AP-Lots 5 & 7 Alphne Road

Building permits for construction of a single family dwelling 24 feet by 32 feet at each of the above named locations is issued herewith based on plans filed with applications for parmit but subject to the following:

BUILDING PERMIT KEPORT ADDRESS REASON FOR PERMIT BUILDING OWNER: . គឺពីរ។ដូង,។ CONTRACTOR: APPROVED: YOUR DISTE DISTE BUT LE PERMIT APPLICANT: pázáce. to Marian 1. QI) DENTED . CONDITION OF APPROVAL OR PENIAL ... _Refore concrete for foundation is placed, approvals from Public Works and Inspection Services must be obtained. (A 24 hour notice is required prior to inspection) Precaution must be taken to protect concrete from freezing.

FRED LUCCI 40 PINE Rd ~ 4x4x13 POSTS ZXZ SPINDLES 5/4'X 6" DECKE 2'x8x10 16'0c E- Y'YY POST 10" x 48" SONA THBE SCALE 3/4 = 1'

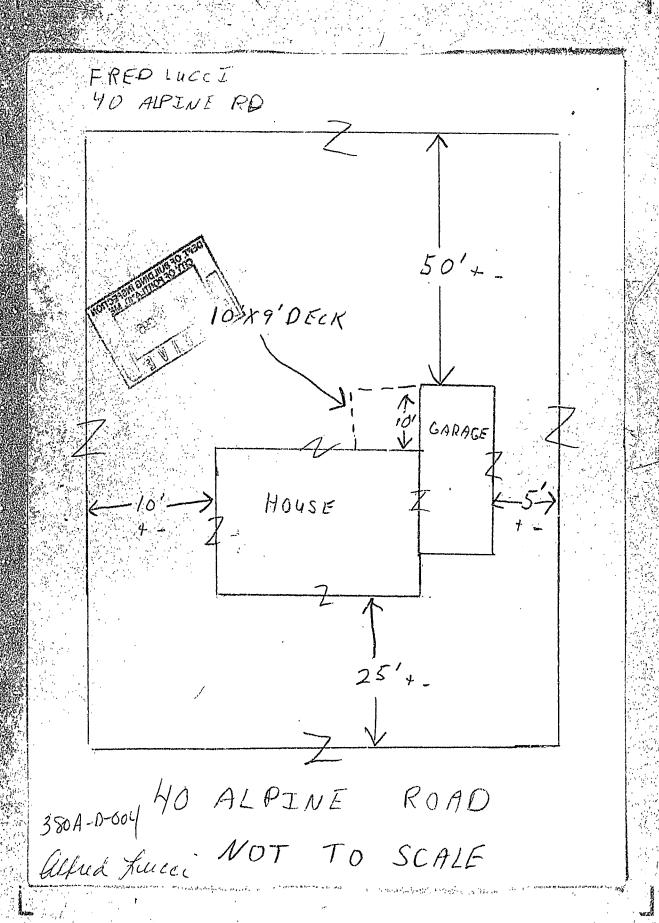
It is strongly recommended that a registered land surveyor check all foundation forms before concrete is placed. This is done to verify that the proper setbacks are maintained.
All vertical openings shall be enclosed with construction having a fire rating of at least one(1) hour, including fire doors with selfclosers. Each apartment shall have access to two(2) separate, remote and approved means of egress. A single exit is acceptable when it exits directly from the apartment to the building exterior with no communications to other apartment units. The boiler shall be protected by enclosing with one(1) hour fire-rated construction including fire doors and ceiling, or by providing automatic extinguishment. Sprinkler piping serving not more than six sprinklers may be connected to a domestic water supply having a capacity sufficient to provide 0.15 gallons per minute, per square foot of floor throughout the entire area. An INDICATING shut-off valve shall be installed in an accessible location between the sprinkler and the connection to the domestic water supply. Minimum pipe size shall be 3/4 inch copper or 1 inch steel. Maximum coverage axea of a residential sprinkler ls 144 sq. feet per sprinkler. Every sleeping room below the fourth story in buildings of Use Groups R and I-1 shall have at least one operable window or exterior door approved for emergency egress or rescue. The units must be operable from the inside without the use of special knowledge or separate tools. Where windows are provided as means of egress or rescue, they shall have a sill height not more than 44 inches (1118mm) above the floor. All egress or rescue windows from sleeping rooms shall have a minimum net clear opening height dimension of 24 inches The minimum net clear opening width dimension shall be 20 (610mm). inches (508 mm), and a minimum net clear opening of 5.7 sq. feet. A portable fire extinguisher shall be located as per NFPA \$10. They shall bear the label of an approved agency and be of an approved type. All single and multiple station smoke detectors shall be of an approved type and shall be installed in accordance with the provisions of the city's building code Chapter 9, section 19, 919.2.2 (BOCA National Building Code/1993), and NFPA 101 Chapter 18 & 19. (Smoke detectors shall be installed and maintained at the following locations):

- ∠H1. Guardrail & Handrails-A guardrail system is a system of building components located near the open cides of elevated walking surfaces for the purpose of minimizing the possibility of an accidental fall from the walking surface to the lower level. Minimum height all Use Groups 42", except Use Group R which is 36". In occupancies in Use Group A, B, H-4, I-1, I-2 M and R and public garages and open parking structures, open guards shall have balusters or be of solid material such that a sphere with a diameter of 4" cannot pass through any opening. Guards shall not have an ornamental pattern that would provide a ladder effect.

- 13. Stair construction in Use Group R-3 & R-4 is a minimum of 9" tread and 6-1/4" maximum rise. All other Use Group minimum 11" tread, 7" maximum rise.
